Project Name: Proposed Front/ Side Porch Addition for Mr. & Mrs. Gleeson

Street Address: 58 Hunt Avenue, Pearl River NY 10965

DENIAL TO THE ZONING BOARD OF APPEALS

Chapter 43, Table 3.12 column 1 RG District, Column 2 Group , Column 3 SFR, Column 8 Required
Front Yard 25' w/ 23'10" proposed.
ONE variances required

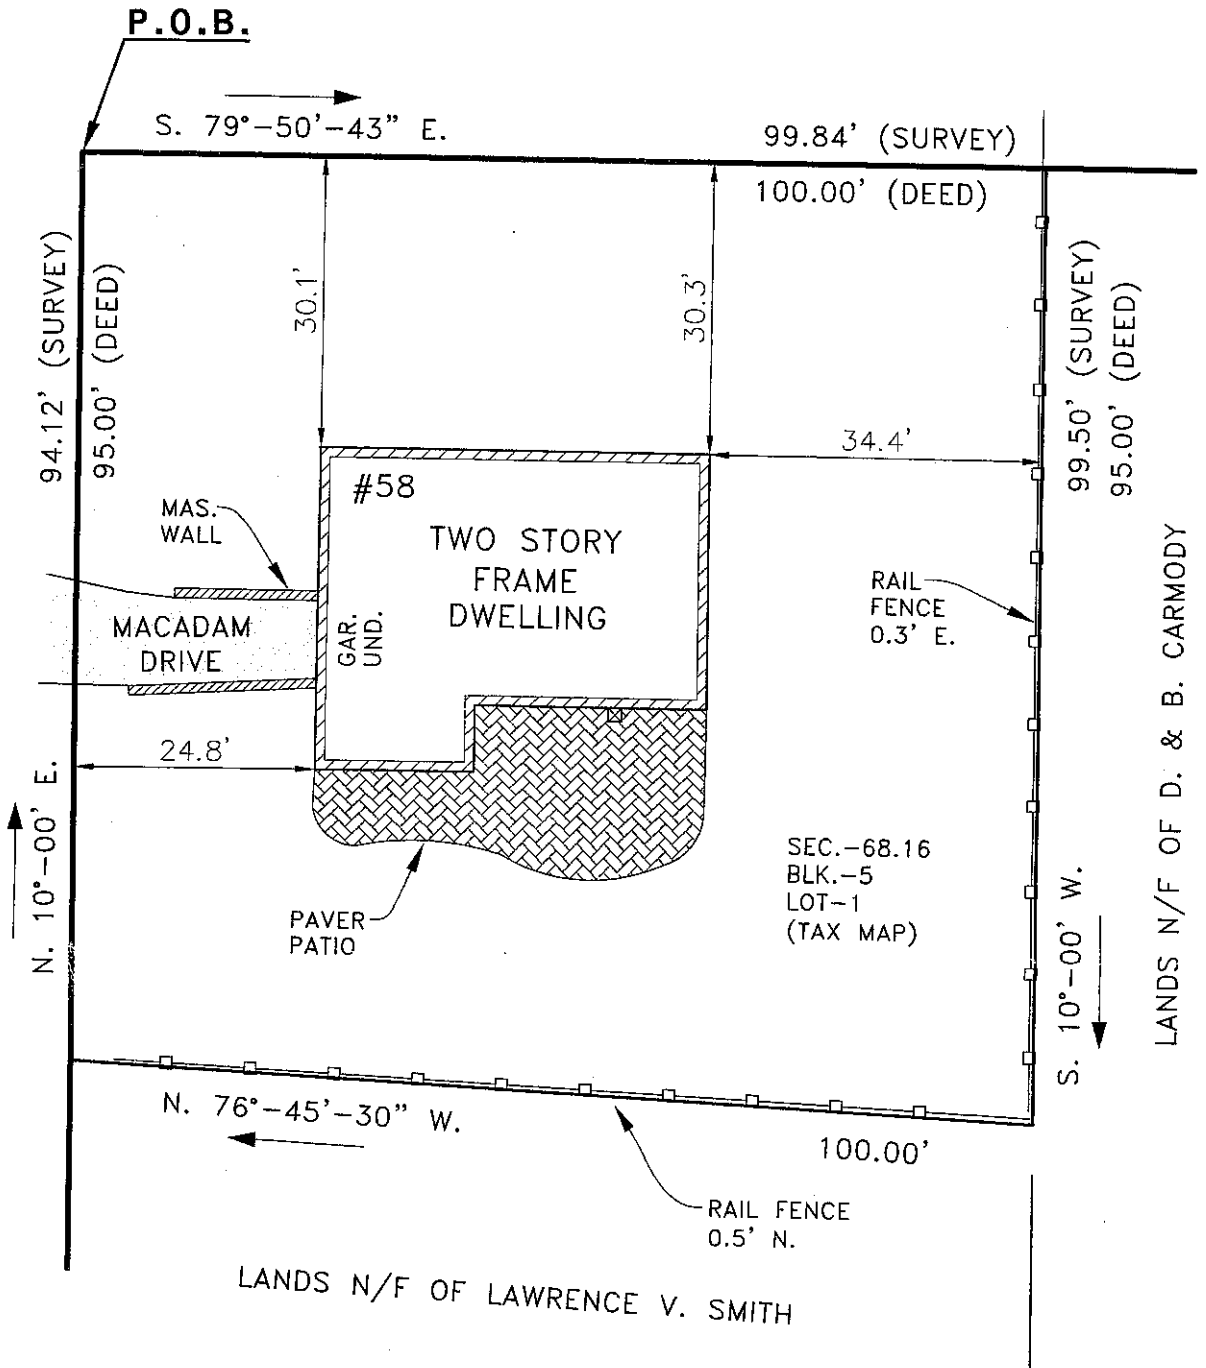
Chapter 45 Table 3.12 Column 1 R6 Column 2 Group C
Column 3 SR. Column 8 Front Yard 25' Required w/ 23' 10"
proposed.
